**5308/5289**

**PARKING SURFACE AND ACCESS/MANEUVERING  
VARIANCES TO RE-OPEN AN EXISTING VARIANCE TO  
ALLOW A GRASS SURFACE PARKING LOT, AND A 12-  
FOOT WIDE, TWO-WAY DRIVEWAY; THE ZONING  
ORDINANCE REQUIRES ALL PARKING TO BE  
ASPHALT, CONCRETE OR AN APPROVED  
ALTERNATIVE PAVING SURFACE, AND A 24-FOOT  
WIDE DRIVE IS REQUIRED FOR TWO WAY ACCESS**

**770 SULLIVAN AVENUE**

**BOARD OF ZONING ADJUSTMENT**

# SITE PLAN

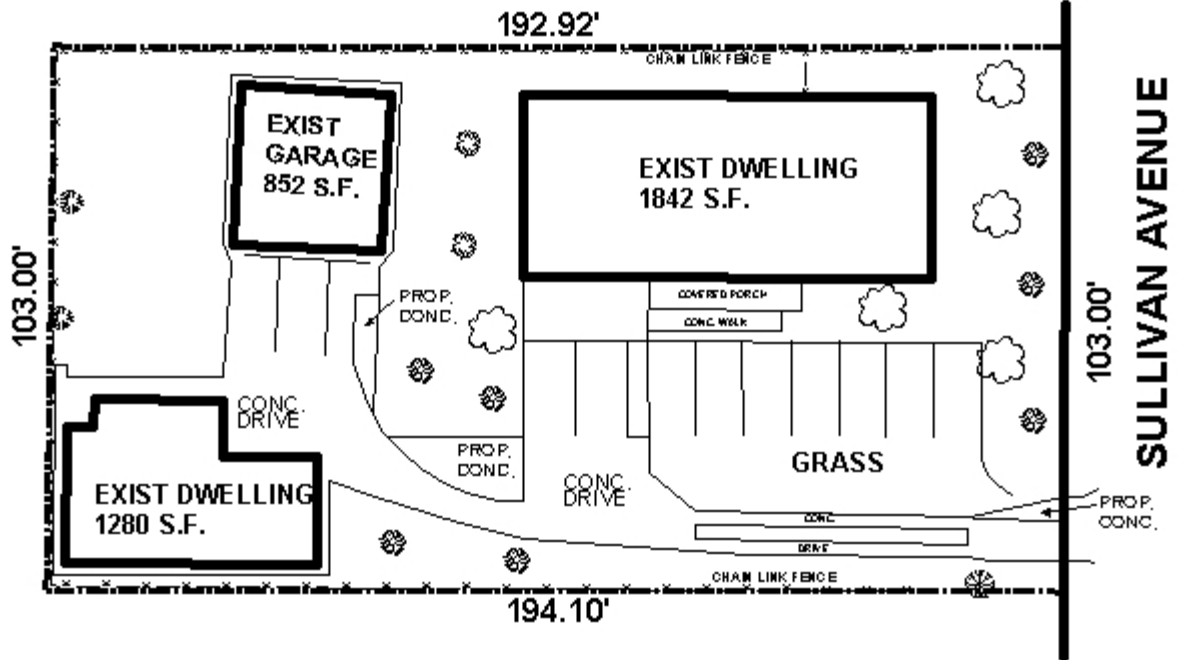
The applicant states that the site cannot retain its residential character with a two-way driveway entrance and eleven paved parking spaces. The applicant proposes to widen the existing driveway to 12-feet for one-way traffic, retain the concrete ribbon strip driveway within the property, and provide a 24-inch wide landing strip for front tires of the vehicles to define the grass parking lot. The applicant states that the three person staff would park on the five existing concrete parking spaces and that the extra grass parking spaces would only be used for visitation on Sunday afternoon. Clients cannot have vehicles on the property during their sessions at the facility. The applicant states that Monday through Saturday, the parking lot will look similar to the front yards of the neighbors.

While there are advantages to asphalt parking lots (aesthetics, drainage, ability to delineate proper parking), there are several disadvantages for allowing parking on a grass surface, such as the inability to delineate parking spaces properly, migration of the soil, and potential damage to the parking areas from conditions after a heavy rainfall. In addition, after months of use, grass becomes "dirt", forming a soft surface that is not beneficial for parking or drainage.

Typically, Traffic Engineering recommends paved parking and access, and the driveway width for commercial sites (as measured behind the sidewalk) is 24-foot wide with a 20-foot radius. A 20' radius for typical passenger vehicles is both desirable and required.

The previous conditions required that the design of the parking area and driveway be approved by Traffic Engineering, and the exterior of the property could retain its residential character with asphalt parking. However, the applicant failed to illustrate that a literal enforcement of the Zoning Ordinance would result in an unnecessary hardship. It is simply the applicant's desire to not furnish the required parking surface and access/maneuvering area.

Based on the preceding, it is the recommendation that the Parking Surface and Access/Maneuvering variances request be denied.
